Group of Experts on Road Signs and Signals

Final report

Submitted by Slovakia

This document contains comments (displayed in the margin) by Slovakia on ECE/TRANS/WP.1/2019/4.

A, 19 c “INTERSECTION WITH A ROAD THE USERS OF WHICH MUST GIVE WAY”

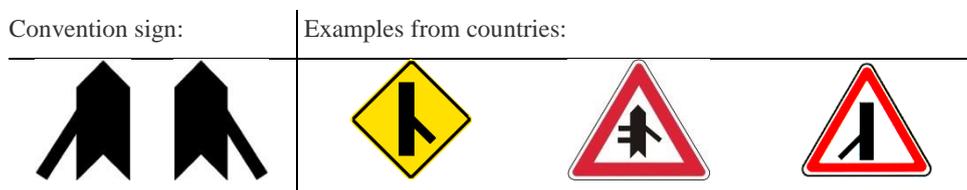
Some countries do not use the arrow head or the “V” shape at the bottom. The Group recommended using the symbol in the Convention without altering it (that is, having the arrow head and the “V” shape at the bottom). The Group clarified that the arrow head and the “V” shape at the bottom, and the differences in the proportion of the line widths, are essential characteristics of the symbol.

B, 5 “PRIORITY FOR ONCOMING TRAFFIC”

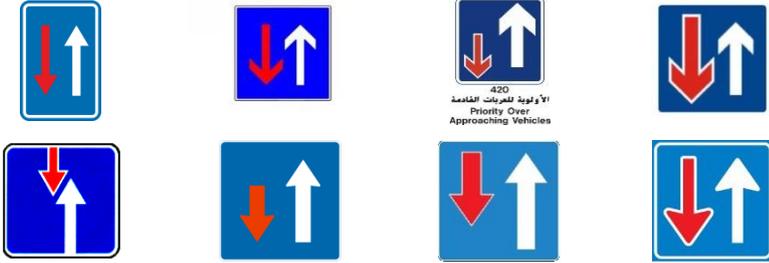
The Group noted that some countries do not use the arrows (i.e. length, width, positioning) as they appear in the Convention. Addressed in in chapter 1 – see issue 11, 12, 35 and 37

Contracting Parties should note the recommendation for this sign in section 1.2 of this document.

E, 1 a “COMPULSORY MINIMUM SPEED APPLYING TO DIFFERENT LANES”

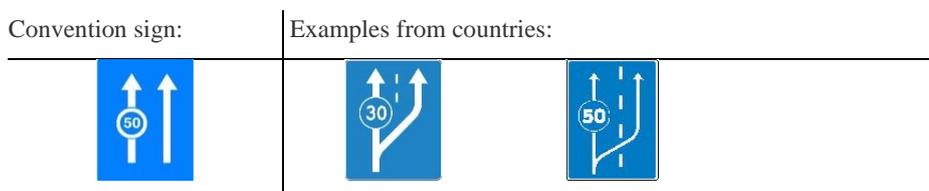
1. Azerbaijan, Hungary, Montenegro, Moldova, Russian Federation, Ukraine and Uzbekistan wrongly use examples for E, 1 b instead of E, 1 a.
2. Many countries use road markings (broken line) on this sign. The Group recommended the symbols on this sign not to include road markings ie., broken lines, as the arrows indicate the “lanes”.
3. The Group recommended that for the E, 1 a sign the sign D, 7 is used with a white rim.

E, 1 b “COMPULSORY MINIMUM SPEED APPLYING TO ONE LANE”

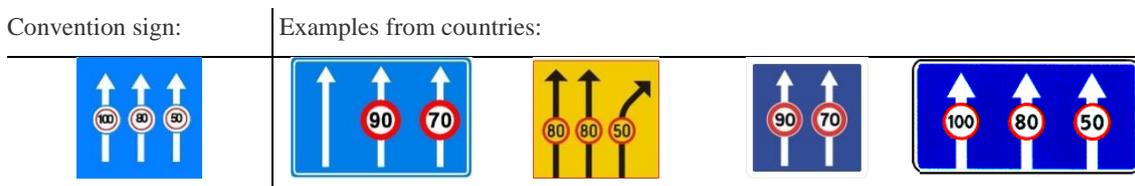
Albania, Croatia and Greece wrongly used examples for E, 1 a instead of E, 1 b.
 Many countries use road markings (broken line) on this sign. The Group recommended the symbols on this sign not to include road markings ie., broken lines as the arrows indicate the “lanes”.

The Group recommended that for the E, 1 b sign the sign D, 7 is used with a white rim.

E, 1 c “SPEED LIMITS APPLYING TO DIFFERENT LANES”

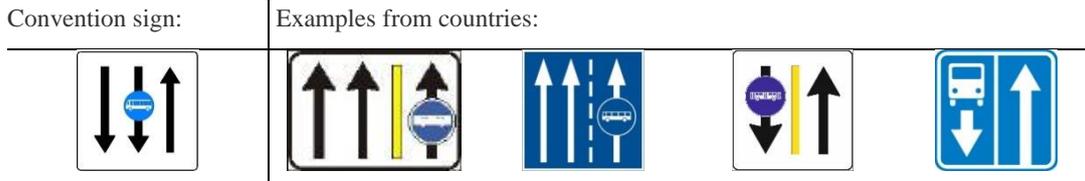
Azerbaijan used a wrong example for E, 1 c sign (truck entry prohibition sign instead of speed limit sign).

The Group recommended that the E, 1 c sign is improved by placing the sign C, 14 on the arrows and adding a white rim.

E, 2 b “SIGNS INDICATING LANES RESERVED FOR BUSES”

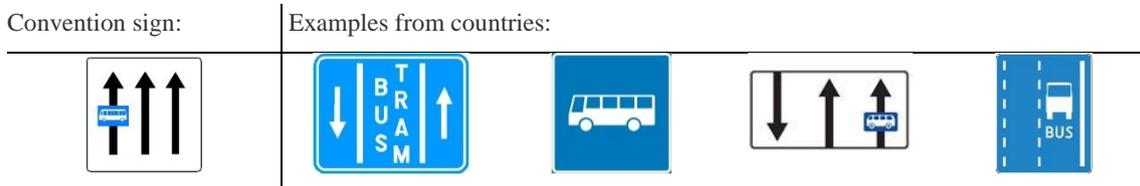
Several countries (Belgium, Croatia, Finland, Latvia, Montenegro, Poland and Ukraine) use examples for E, 2 b that do not correspond to the examples of the Convention.

E, 18 a “STOPPING PLACE IN CASE OF EMERGENCY OR DANGER”

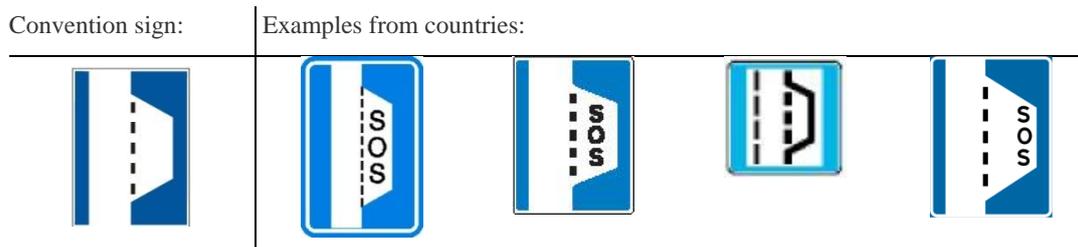
The Group noted that some countries (Croatia and Norway) included the inscription S.O.S in the sign. Placing the S.O.S inscription the Group considers to be in conformity with the Convention. Placing the inscription within a red square on the sign (Croatia) is however considered not to be in Conformity with the Convention.

The Group also noted that one country (Austria) used a sign with an inscription of a distance to the stopping place, which is considered not to be in conformity with the Convention.

Contracting Parties should note the recommendation for this sign in section 1.2 of this document.

G, 2a and G, 2b “NO THROUGH ROAD” (advance direction signs)

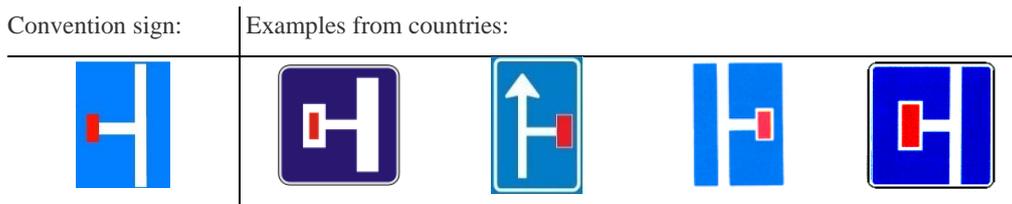
1. The Group also noted that the G, 2a Slovakian sign had a white border, instead of a rim, around the red bar. The Group further noted that the G, 2a sign from the Netherlands contained an arrow. The Group considered these signs not to be in conformity with the Convention.

G, 11a, 11b, 11c, 12a and 12b Signs indicating the number and direction of traffic lanes

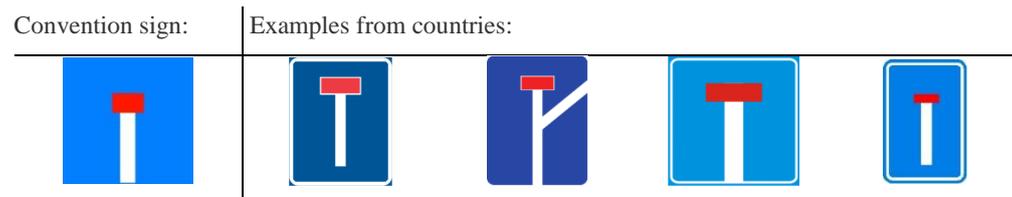
1. The Group noted that some countries used different colours for the ground and symbol (i.e. blue/green ground and white symbol) in addition to the white ground and black symbol for the Convention sign. In this regard, the Group noted that the Convention did not specify what colours are permitted for this sign. However, it did note that the Convention specified that the use of orange symbols may be used for temporary indication signs. Addressed in in chapter 1 – issue 36
